REQUEST FOR PROPOSALS No. 24-031

French Creek Pollution Control Centre Morningstar Creek Crossing Replacement

Addendum 1 Issued: May 13, 2024

PROJECT:		FRENCH CREEK POLLUTION CONTROL CENTRE STAGE 4 EXPANSION - EARLY WORKS	
DWG NO:	FCPC-C-SHT-C-1006	REV:	0

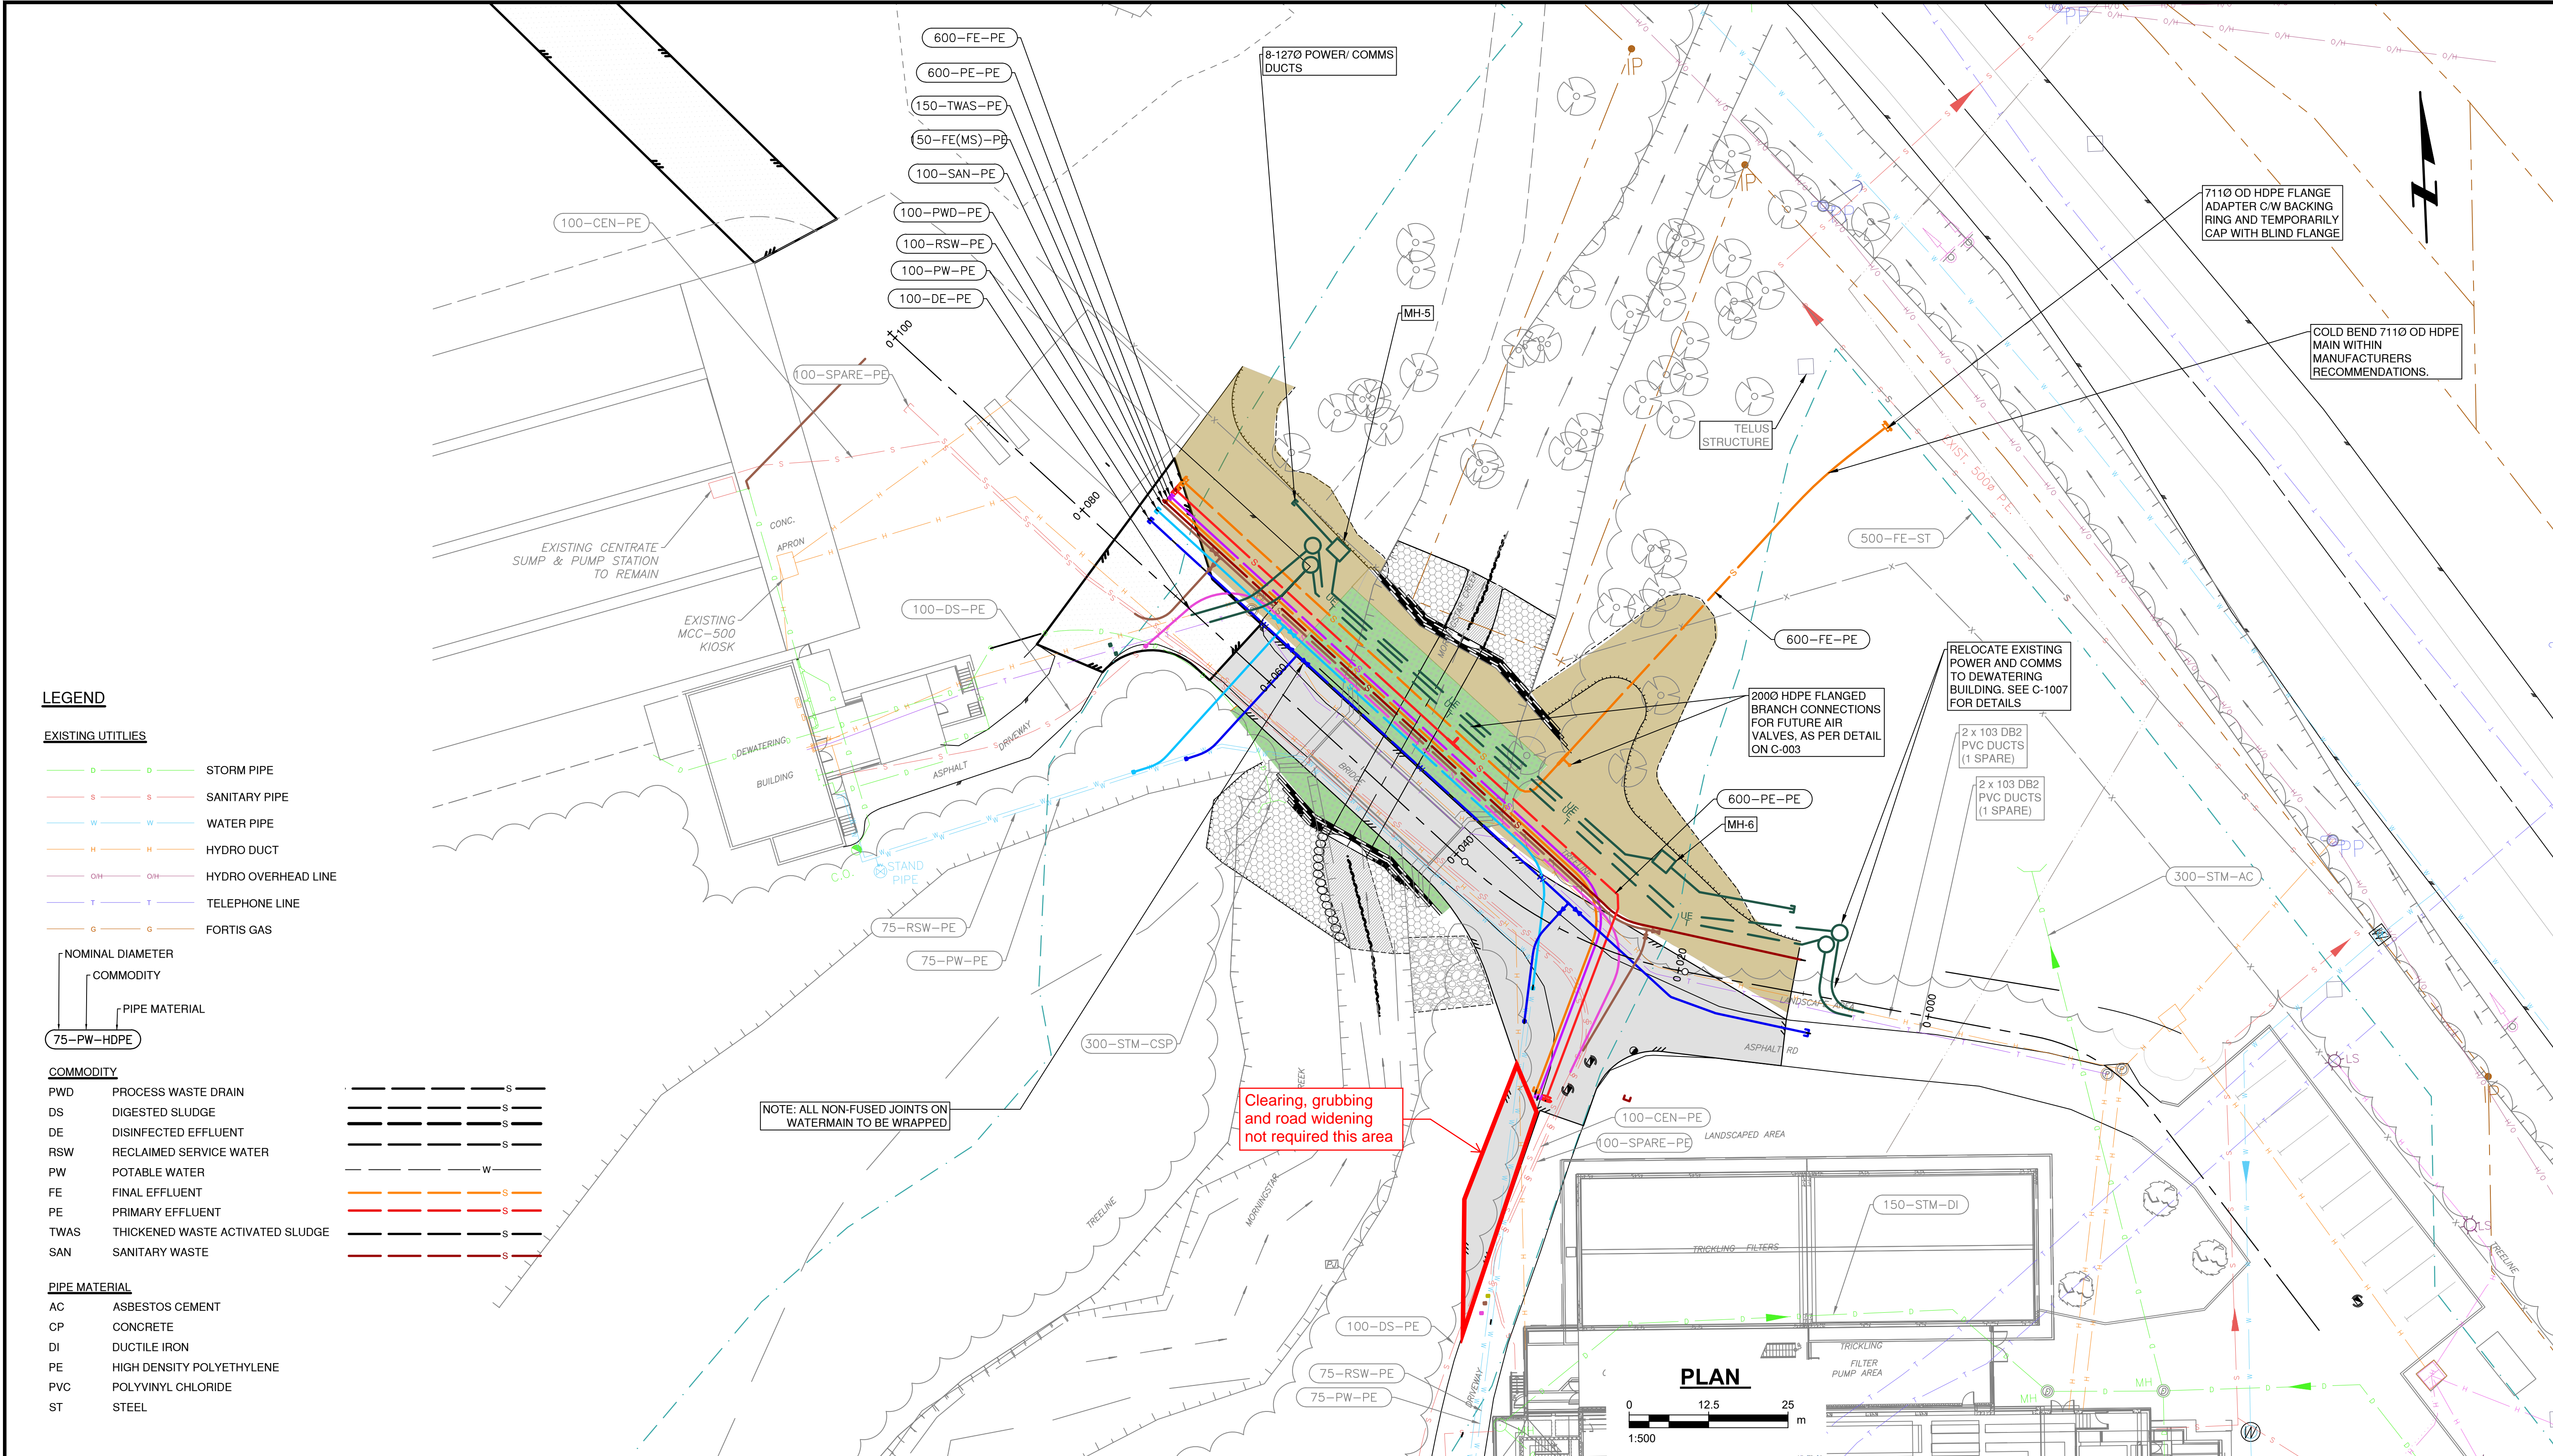
1. Add attached sketch. Clearing, grubbing and road widening not required in area shown in attached sketch.
2. Add disposal of berm materials (Item 3.2(d) in Schedule of Quantities and Prices, blue hatched area on Dwg. C-1005) to be disposed at GRT Soil Processing at 730 Daholt Road in Nanaimo.
3. Add Pollution/Environmental Impairment Liability Insurance (EIL) minimum \$5M per occurrence/\$5M aggregate, maximum \$50,000 deductible, in addition to the insurance requirements noted in Item 7 of the Sample Form of Contract in Appendix H.
4. Add the enclosed mandatory sit visit attendance list.

Clearing, grubbing and road widening not required this area
